## Issue List

### NCANG Repair Bldg 51 (Charlotte, NC)

**Issue Name :** EF-15 Not Operational

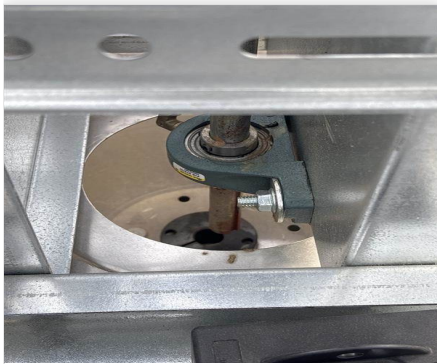
**Description :** EF-15 shaft to the blower is not connected at this time.

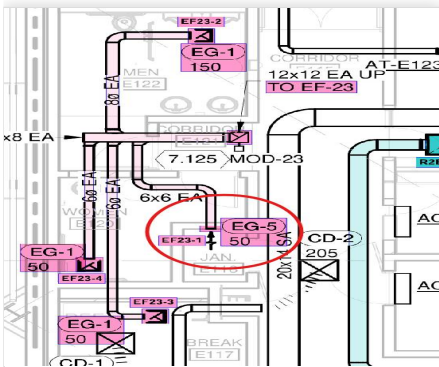
**Issue Name :** EF-23 High Flow  
**Description :** EF-23 is 37% above design (407 CFM ACTUAL / 300 CFM DESIGN) and requires a sheave change to reduce flow. Motor sheave is on the lowest setting. Unable to balance due to a diffuser missing as well.  
**Created By :** National TAB                      **Assigned To :** National TAB - Antonio Flores-De La Cruz  
**Status :** Open  
**Priority :** Urgent                                      **Asset Tag :**  
**Originated Date :** 02/12/2026 - Antonio Flores-De La Cruz - National TAB

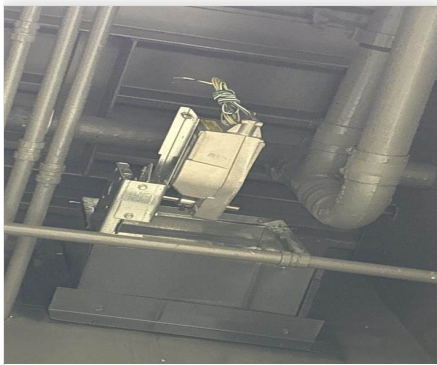
**Issue Name :** EF-26 Low Flow  
**Description :** EF-26 is at 66% of design (99 CFM ACTUAL / 150 CFM DESIGN). The speed dial is at max. A possible cause could be a partially opened exhaust motorized damper. It was found that there is a damper at the takeoff and one at the arm of the equipment where the duct connects, which may add resistance to the system.

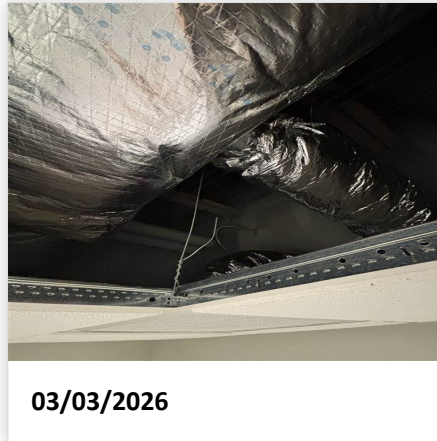
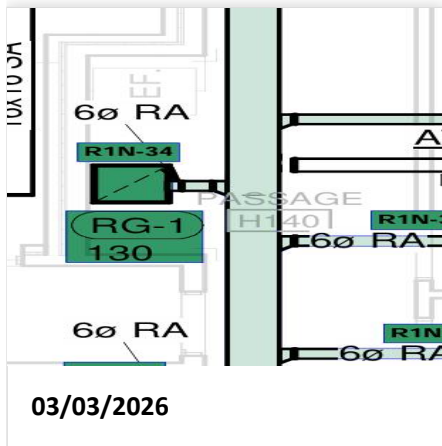
**Issue Name :** Hanger EFs Not Operational  
**Description :** EF-9 through EF-19, EXCEPT EF-13, are not operational. Controls stated the exhaust fans might be wired incorrectly. Further investigation is required.  
**Created By :** National TAB                      **Assigned To :** National TAB - Antonio Flores-De La Cruz  
**Status :** Open  
**Priority :** Urgent                                      **Asset Tag :**  
**Originated Date :** 02/12/2026 - Antonio Flores-De La Cruz - National TAB

- **03/05/2026    National TAB - Antonio Flores-De La Cruz**
  - MECHANICAL STATED ALL BUT EF-9, EF-14, AND EF-15 ARE OPERATIONAL NOW. WILL CHECK AND TAB

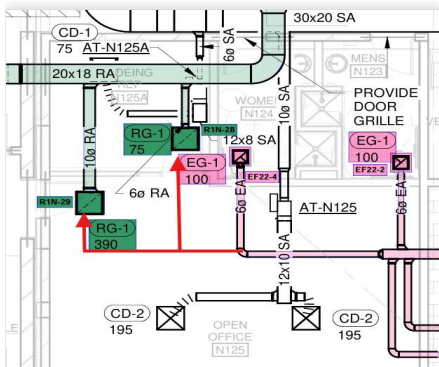
**Issue Name :** Incorrectly Installed Duct for Return  
**Description :** Grilles R1N-28 and R1N-29 were attached to EF-22 ductwork.  
**Created By :** National TAB                      **Assigned To :** National TAB - Antonio Flores-De La Cruz  
**Status :** Open  
**Priority :** **Urgent**                                      **Asset Tag :**  
**Originated Date :** 03/03/2026 - Antonio Flores-De La Cruz - National TAB

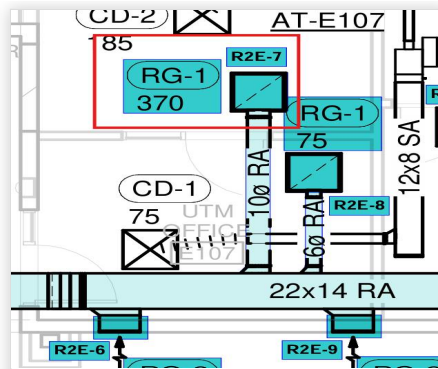
**Issue Name :** Missing Damper for Return Grille  
**Description :** Return Grille R2E-7 in E107A is missing the damper to balance.  
**Created By :** National TAB                      **Assigned To :** National TAB - Antonio Flores-De La Cruz  
**Status :** Open  
**Priority :** Urgent                                      **Asset Tag :**  
**Originated Date :** 03/02/2026 - Antonio Flores-De La Cruz - National TAB

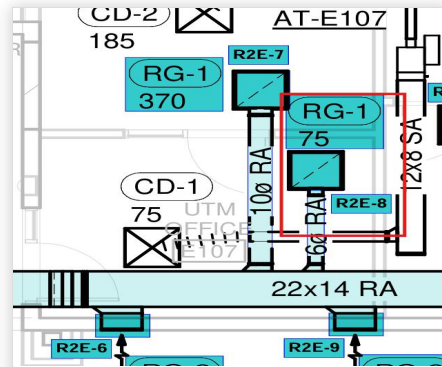
**Issue Name :** Missing Damper for Return Grille in E107  
**Description :** Grille R2E-8 is missing the damper to balance.  
**Created By :** National TAB                      **Assigned To :** National TAB - Antonio Flores-De La Cruz  
**Status :** Open  
**Priority :** Urgent                                      **Asset Tag :**  
**Originated Date :** 03/02/2026 - Antonio Flores-De La Cruz - National TAB

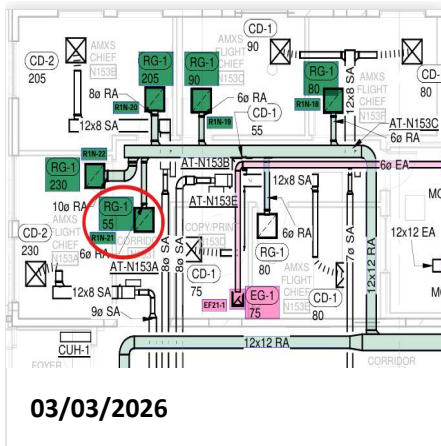
**Issue Name :** Missing Return Damper for CORRIDOR N153  
**Description :** Grille R1N-21 is missing the damper ot TAB.  
**Created By :** National TAB **Assigned To :** National TAB - Antonio Flores-De La Cruz  
**Status :** Open  
**Priority :** **Urgent** **Asset Tag :**  
**Originated Date :** 03/03/2026 - Antonio Flores-De La Cruz - National TAB

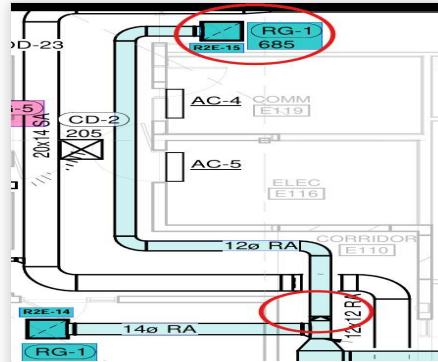
**Issue Name :** Missing Return Damper in OPEN OFFICE E123  
**Description :** Damper for Grille R2E-15 is missing to balance.  
**Created By :** National TAB **Assigned To :** National TAB - Antonio Flores-De La Cruz  
**Status :** Open  
**Priority :** Urgent **Asset Tag :**  
**Originated Date :** 03/02/2026 - Antonio Flores-De La Cruz - National TAB

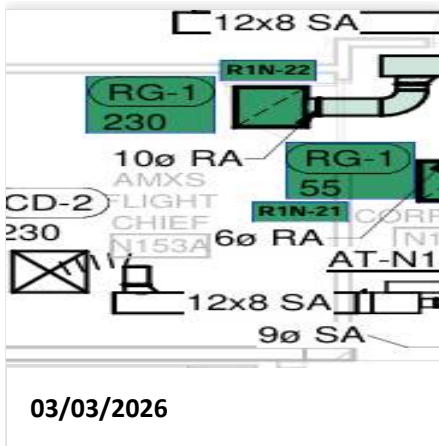
**Issue Name :** Missing Return Damper in ROOM AMXS FLIGHT CHIEF N153A  
**Description :** Grille R1N-22 is missing the damper to TAB.  
**Created By :** National TAB                      **Assigned To :** National TAB - Antonio Flores-De La Cruz  
**Status :** Open  
**Priority :** Urgent                                      **Asset Tag :**  
**Originated Date :** 03/03/2026 - Antonio Flores-De La Cruz - National TAB

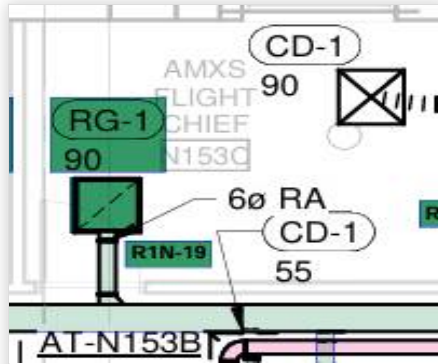
**Issue Name :** Missing Return Damper in ROOM AMXS FLIGHT CHIEF N153C  
**Description :** Grille R1N-19 is missing the damper to TAB.  
**Created By :** National TAB                      **Assigned To :** National TAB - Antonio Flores-De La Cruz  
**Status :** Open  
**Priority :** Urgent                                      **Asset Tag :**  
**Originated Date :** 03/03/2026 - Antonio Flores-De La Cruz - National TAB

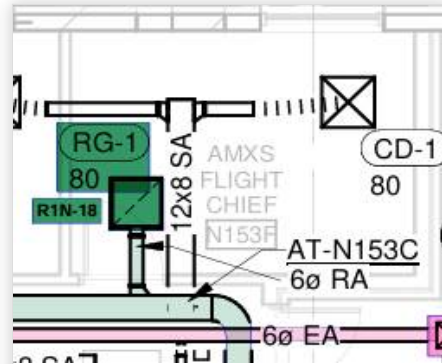
**Issue Name :** Missing Return Damper in ROOM AMXS FLIGHT CHIEF N153F  
**Description :** Grille R1N-18 is missing the damper to TAB.  
**Created By :** National TAB                      **Assigned To :** National TAB - Antonio Flores-De La Cruz  
**Status :** Open  
**Priority :** Urgent                                      **Asset Tag :**  
**Originated Date :** 03/03/2026 - Antonio Flores-De La Cruz - National TAB

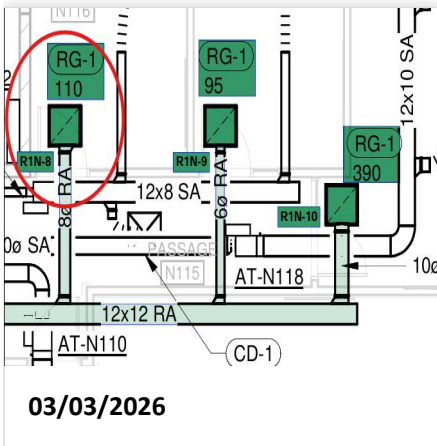
**Issue Name :** Missing Return Damper in ROOM AVIONICS ELEMENT CHIEF N116  
**Description :** Grille R1N-8 is missing the damper to TAB.  
**Created By :** National TAB                      **Assigned To :** National TAB - Antonio Flores-De La Cruz  
**Status :** Open  
**Priority :** **Urgent**                                      **Asset Tag :**  
**Originated Date :** 03/03/2026 - Antonio Flores-De La Cruz - National TAB

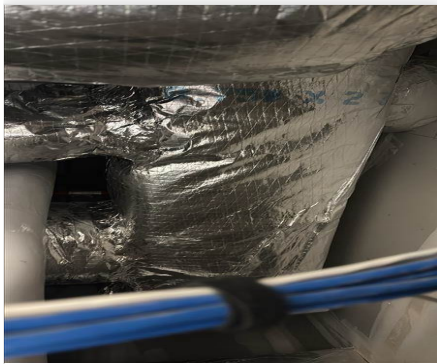
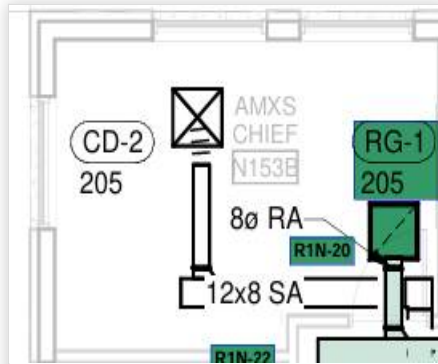
**Issue Name :** Missing Return Damper in ROOM AXMS CHIEF N153B  
**Description :** Grille R1N-20 is missing the damper to TAB.  
**Created By :** National TAB                      **Assigned To :** National TAB - Antonio Flores-De La Cruz  
**Status :** Open  
**Priority :** Urgent                                      **Asset Tag :**  
**Originated Date :** 03/03/2026 - Antonio Flores-De La Cruz - National TAB

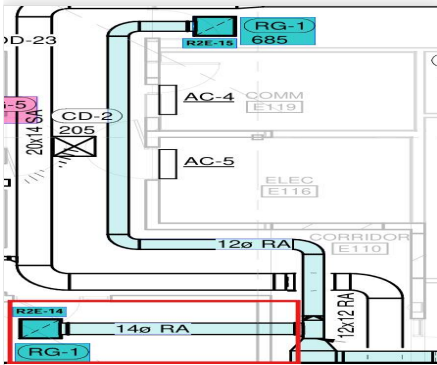
**Issue Name :** Missing Return Damper in ROOM CLASSROOM E108  
**Description :** Damper for Grille R2E-14 in ROOM CLASSROOM E108 is missing to balance.  
**Created By :** National TAB                      **Assigned To :** National TAB - Antonio Flores-De La Cruz  
**Status :** Open  
**Priority :** **Urgent**                                      **Asset Tag :**  
**Originated Date :** 03/02/2026 - Antonio Flores-De La Cruz - National TAB

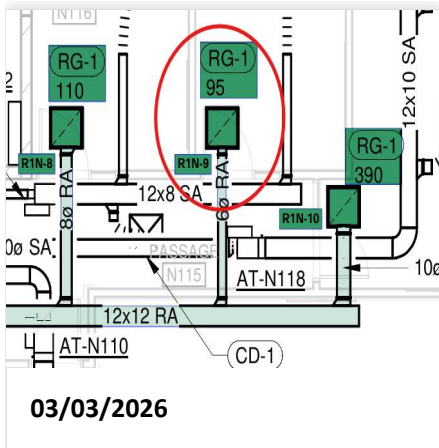
**Issue Name :** Missing Return Damper in ROOM CMF CHIEF N117  
**Description :** Grille R1N-9 is missing the damper to TAB.  
**Created By :** National TAB                      **Assigned To :** National TAB - Antonio Flores-De La Cruz  
**Status :** Open  
**Priority :** **Urgent**                                      **Asset Tag :**  
**Originated Date :** 03/03/2026 - Antonio Flores-De La Cruz - National TAB

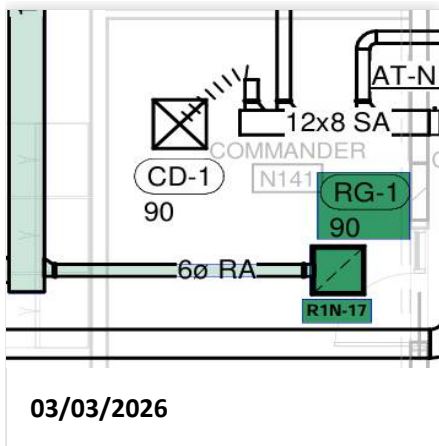
**Issue Name :** Missing Return Damper in ROOM COMMANDER N141  
**Description :** Grille R1N-17 is missing the return damper to TAB.  
**Created By :** National TAB                      **Assigned To :** National TAB - Antonio Flores-De La Cruz  
**Status :** Open  
**Priority :** Urgent                                      **Asset Tag :**  
**Originated Date :** 03/03/2026 - Antonio Flores-De La Cruz - National TAB

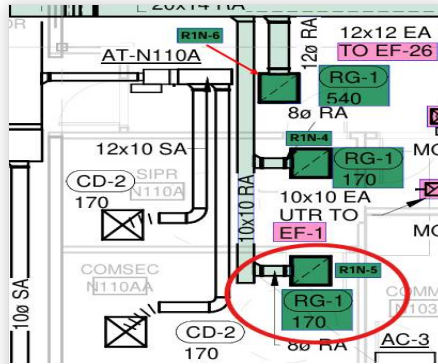
**Issue Name :** Missing Return Damper in ROOM COMSEC N110AA  
**Description :** Grille R1N-5 is missing the damper to TAB.  
**Created By :** National TAB **Assigned To :** National TAB - Antonio Flores-De La Cruz  
**Status :** Open  
**Priority :** Urgent **Asset Tag :**  
**Originated Date :** 03/03/2026 - Antonio Flores-De La Cruz - National TAB

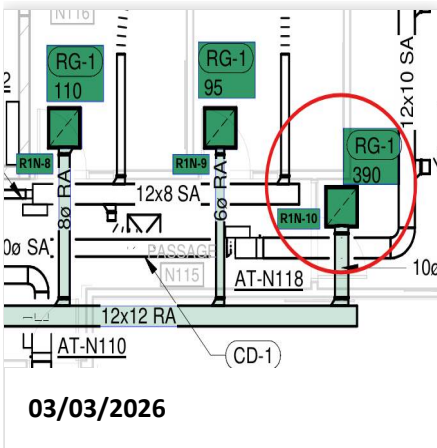
**Issue Name :** Missing Return Damper in ROOM CONFERENCE N118  
**Description :** Grille R1N-10 is missing the damper to TAB.  
**Created By :** National TAB                      **Assigned To :** National TAB - Antonio Flores-De La Cruz  
**Status :** Open  
**Priority :** **Urgent**                                      **Asset Tag :**  
**Originated Date :** 03/03/2026 - Antonio Flores-De La Cruz - National TAB

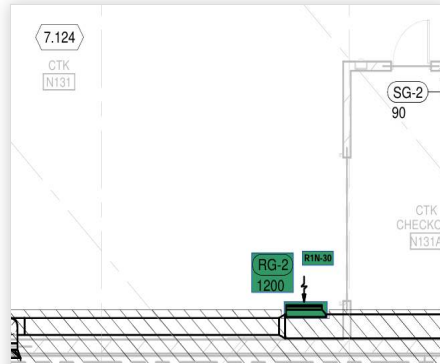
**Issue Name :** Missing Return Damper in ROOM CTK N131  
**Description :** Grille R1N-30 is missing the damper to TAB.  
**Created By :** National TAB                      **Assigned To :** National TAB - Antonio Flores-De La Cruz  
**Status :** Open  
**Priority :** Urgent                                      **Asset Tag :**  
**Originated Date :** 03/03/2026 - Antonio Flores-De La Cruz - National TAB

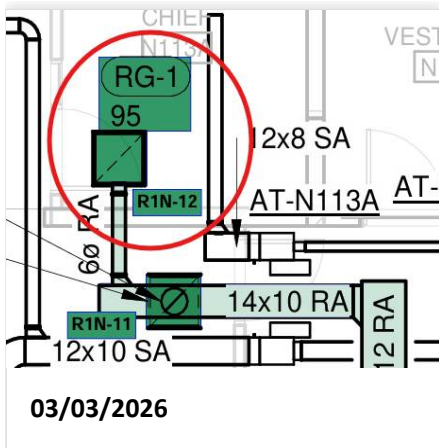
**Issue Name :** Missing Return Damper in ROOM ENG ELEMENT CHIEF N113A  
**Description :** Grille R1N-12 is missing the damper to TAB.  
**Created By :** National TAB                      **Assigned To :** National TAB - Antonio Flores-De La Cruz  
**Status :** Open  
**Priority :** **Urgent**                                      **Asset Tag :**  
**Originated Date :** 03/03/2026 - Antonio Flores-De La Cruz - National TAB

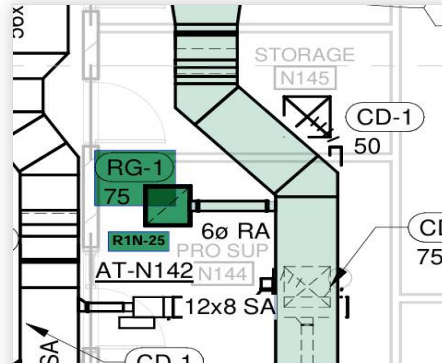
**Issue Name :** Missing Return Damper in Room PRO SUP N144  
**Description :** Return Damper for Grille R1N-45 is missing to TAB.  
**Created By :** National TAB                      **Assigned To :** National TAB - Antonio Flores-De La Cruz  
**Status :** Open  
**Priority :** Urgent                                      **Asset Tag :**  
**Originated Date :** 03/03/2026 - Antonio Flores-De La Cruz - National TAB

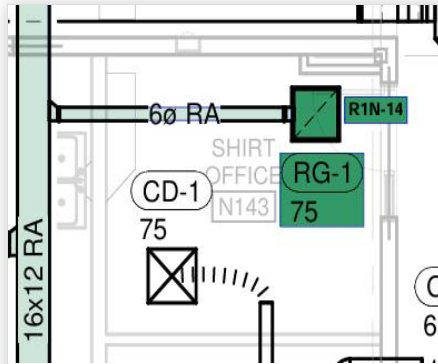
**Issue Name :** Missing Return Damper in ROOM SHIRT OFFICE N143  
**Description :** Grille R1N-14 is missing the return damper to TAB.  
**Created By :** National TAB                      **Assigned To :** National TAB - Antonio Flores-De La Cruz  
**Status :** Open  
**Priority :** Urgent                                      **Asset Tag :**  
**Originated Date :** 03/03/2026 - Antonio Flores-De La Cruz - National TAB

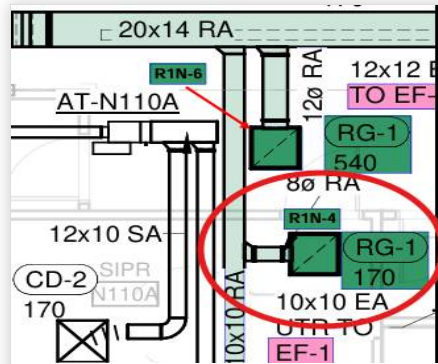
**Issue Name :** Missing Return Damper in ROOM SIPR N110A  
**Description :** Grille R1N-4 is missing the damper to TAB.  
**Created By :** National TAB **Assigned To :** National TAB - Antonio Flores-De La Cruz  
**Status :** Open  
**Priority :** Urgent **Asset Tag :**  
**Originated Date :** 03/03/2026 - Antonio Flores-De La Cruz - National TAB

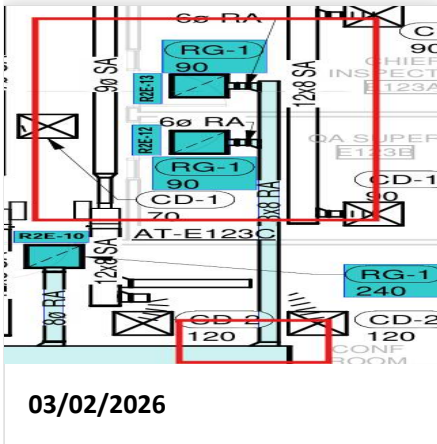
**Issue Name :** Missing Return Dampers in Offices  
**Description :** Grilles R2E-12 and R2E-13 are missing their dampers to balance the return.  
**Created By :** National TAB                      **Assigned To :** National TAB - Antonio Flores-De La Cruz  
**Status :** Open  
**Priority :** **Urgent**                                      **Asset Tag :**  
**Originated Date :** 03/02/2026 - Antonio Flores-De La Cruz - National TAB

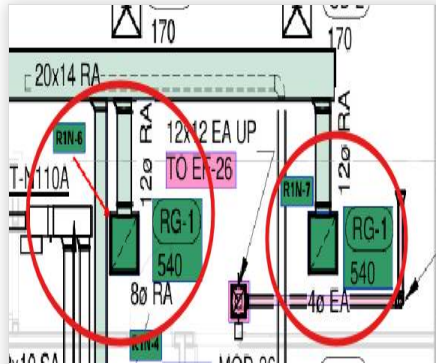
**Issue Name :** Missing Return Dampers in ROOM AVIONICS N110  
**Description :** Grilles R1N-6 and R1N-7 are missing the dampers to TAB.  
**Created By :** National TAB                      **Assigned To :** National TAB - Antonio Flores-De La Cruz  
**Status :** Open  
**Priority :** Urgent                                      **Asset Tag :**  
**Originated Date :** 03/03/2026 - Antonio Flores-De La Cruz - National TAB

**Issue Name :** MUA-2 Dirty Filters

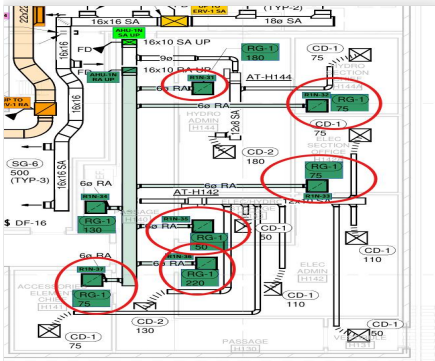
**Description :** MUA-2 filters are dirty and must be changed to TAB.

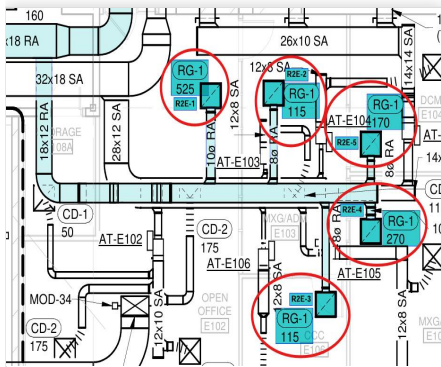
**Issue Name :** Multiple Return Dampers missing  
**Description :** Dampers for Return Grilles: RE2-1 through RE2-5 are missing to balance.  
**Created By :** National TAB                      **Assigned To :** National TAB - Antonio Flores-De La Cruz  
**Status :** Open  
**Priority :** **Urgent**                                      **Asset Tag :**  
**Originated Date :** 03/02/2026 - Antonio Flores-De La Cruz - National TAB

**Issue Name :** PAH-1 Stages Issues

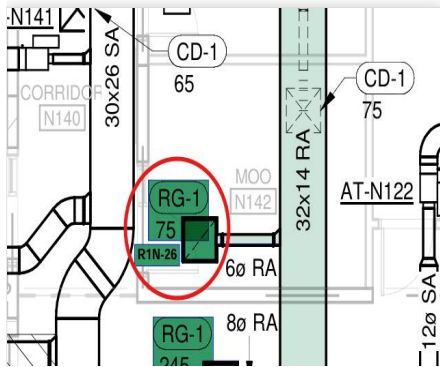
**Description :** PAH-1 is having issues with selecting stages, specifically heating. Unit is only going into Cooling, no heating. Controls is going to get access to the communications room from the Military, and he will see what's going on with the TSAT, but stated it could be a mechanical/service issue. WINTER LAT/EAT is needed.
